REVISIONS JAN/08

PROPOSED SITE PLAN

ASSESSORS PLAT 6B, LOT 5-49
WHISPERING PINES ROAD, POLE #8
RICHMOND, RHODE ISLAND

SCALE: 1"=20' SHEET 1 OF 1 DWG. 5722-2
AUGUST, 2007 REVISED FEBRUARY, 2008

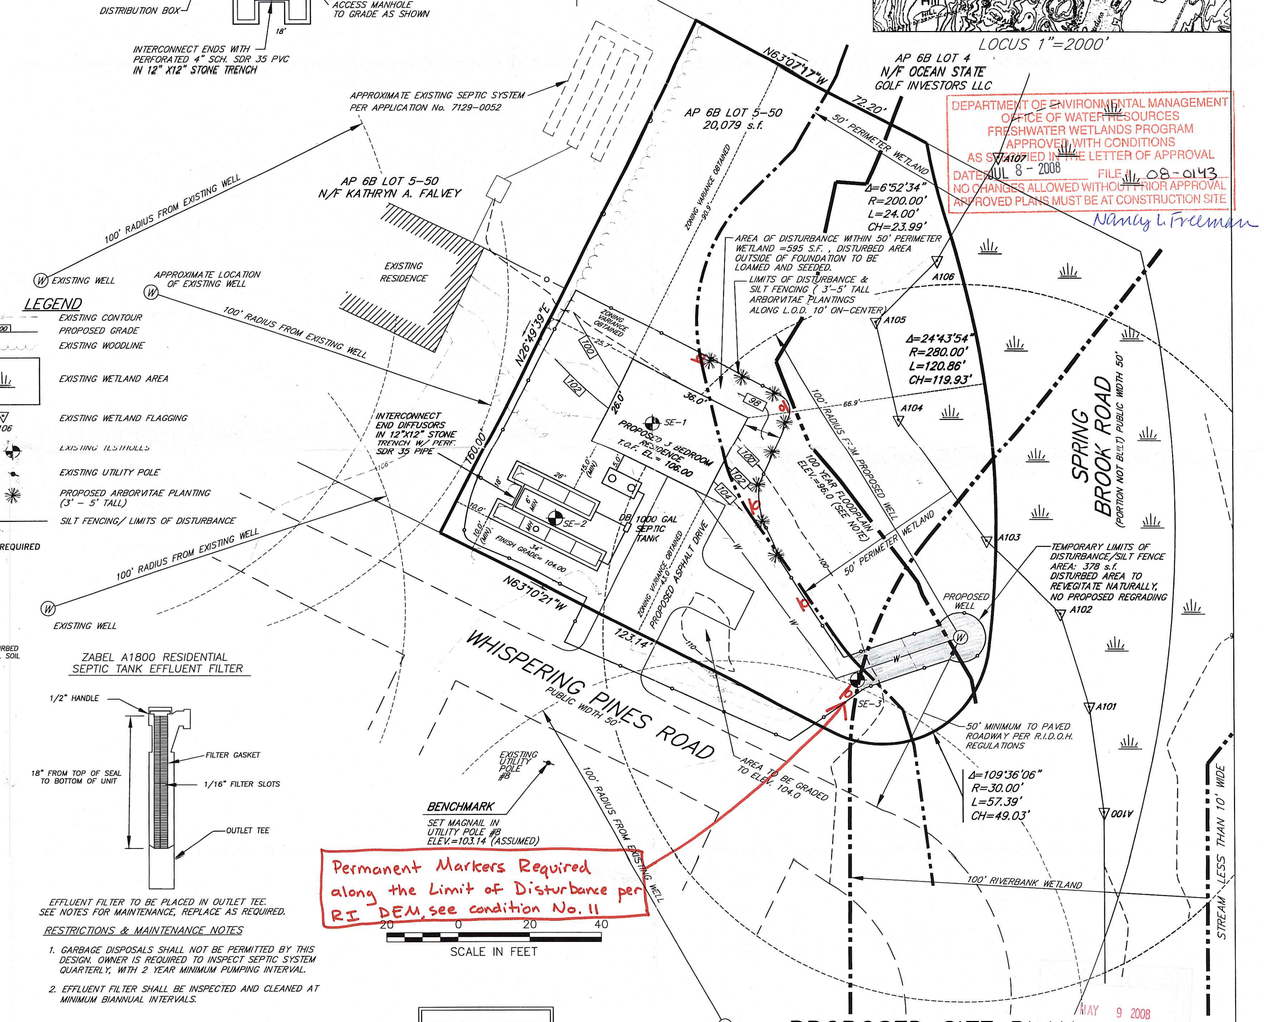
THE DWELLING FOOTPRINT HAS BEEN REDUCED BY REMOVING THE GARAGE.

THE LIMITS OF DISTURBANCE HAS BEEN REVISED TO ENCOMPASS ONLY 10' AROUND THE PROPOSED STRUCTURE, AND ENCOMPASS THE ENTIRE SITE.

TO DECREASE THE ENVIRONMENTAL IMPACTS, DIMENSIONAL VARIANCES FOR FRONT, SIDE, AND REAR SETBACKS HAVE BEEN OBTAINED.

RELIEF FROM THE RICHMOND ZONING BOARD REVIEW WAS GRANTED ON OCT. 22, 2007 THE REQUIRED SETBACK HAS BEEN REDUCED TO 43' FROM THE REQUIRED 50'. THE SIDE SETBACK HAS BEEN REDUCED TO 25' FROM THE REQUIRED 35' SETBACK.

Permanent Markers Required along the Limit of Disturbance per RI DEM, see condition No. 11
